# structural forum

## Results for March Drawing Quality article

3 TYPICAL SPANDREL SECTION

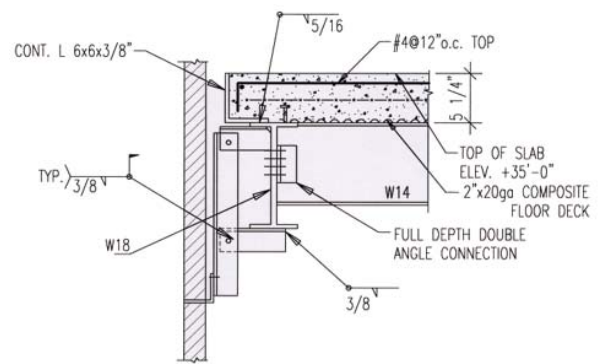
1. Welded wire reinforcing shown too far down below top of slab

2. WWR shown out of scale. Cross wires should be drawn at 6" o.c.

3. No length indicated for reinforcing bars

4. Reinforcing bar bends have a radius on them. It's not good detailing practice to draw sharp bar bends (especially for the larger bar sizes.)

5. When pointing to the top of a slab the leader arrow should not be pointing to the underside of the top surface – it should point down onto the top of the slab.

6. 2" deep floor deck is drawn out of scale.

7. 2" deep floor deck is not drawn with the correct deck profile for composite floor deck commonly used in the U.S.

8. "All around" weld symbol is not appropriate when a continuous angle is welded to the top flange of a beam.

9. "All around" weld symbol (the circle) is drawn too small. (note: See page 8-31 of the 3rd Edition AISC Manual for additional info on how weld symbols should look.)

10. Fillet weld size is shown on wrong side of fillet weld triangle.

11. Fillet weld symbol (triangle) is drawn backwards.

12. Fillet weld symbol is drawn too small and should be drawn as a 45-degree right triangle.

13. Headed stud on beam flange is drawn too small and out of proportion (head too big).

14. Edge of relieving angle should not be drawn flush with face of brick.

15. Brick as drawn makes no reference to the soft joint required between the underside of the relieving angle and top of brick.

16. It's bad practice to show too much information pertaining to non-structural items on structural details. The face brick is non-structural and structural engineers need only show a single line representative of the approximate location of the outside of the brick. There should also be a note saying something like, "facade brick, see architectural drawings". As drawn the detail could be interpreted to indicate that:

i. Face of brick is flush with tip of angle

ii. No soft joint required

iii. No sealant joint required

iv. No weep holes required

v. No flashing required.

17. Detail is vague on how relieving angle is to connect to the hanger angles.

18. No size or spacing indicated for the angles.

19. Field weld flag drawn "too skinny". (See the AISC Manual for a "go by" flag.)

20. Fillet weld size shown is probably way bigger than needed. 3/8" fillet welds require multiple passes (expensive).

21. Weld arrow is not pointing at anything and is not pointing in correct direction.

22. Vertical angle can't be welded or bolted to the horizontal angle if the outstanding leg of the angle is oriented as shown.

23. Solid lines can't overlap solid lines. Which angle is in front?

24. 6x6 angle should have small fillet where the inside face of the vertical and horizontal legs meet.

25. Size of continuous reinforcing bar not shown.

26. 6x6 angle is too big for the 5 1/4" thick slab. The vertical leg of the angle will stick above the top of the slab and make it difficult to screed the concrete.

27. The 6x6 angle is also much bigger than is needed (i.e., a waste of steel). A gage metal pour stop would probably be more appropriate for this condition.

28. W shape beam not drawn properly. Webs are never thicker than the flanges. Fillets occur at intersections between flanges and web.

29. There should be a gap shown between end of the beam and web of supporting girder (about 1/2").

30. Information on welds between the angles and W shape are missing.

31. Bolts should be drawn at 3" o.c.

32. First row of bolts is drawn too far down from top of beam. (First row of bolts is normally 3" down from top of beam)

33. Connections at the ends of W14 beams normally don't have more than 3 rows of bolts when double angle connections are used.

34. Top of W14 beam should be shown with the top flange coped where it connects to the girder.

35. Weld leader arrow is not pointing to the correct spot.

36. Weld all around requirement and 3/8" fillet weld is way more weld than is probably needed.

37. How far down is relieving angle from bottom of the supporting hanger angle? (i.e., is it ok if the bottom of the hanger terminates 3" above the bottom of the relieving angle? (Probably not!)

38. Line too short (ok, so I'm a nit-pick!)

a. No need to show top of slab elevation on detail if it is indicated on the framing plan (which it should be)

b. No need to specify type and gage of floor deck if it is specified on the framing plan (which it should be).

c. Be consistent with the way leaders are drawn. (i.e., justification of leader line with respect to text.)

d. There is usually no need to hatch concrete (showing stone). This often just clutters up the detail and can obscure the reinforcing steel in the slab.

e. No need to show the slab thickness in the sections and details if this information is shown on the framing plans (which it should be).

f. If the section is cut on plan, then there's really no reason to give it a title.■
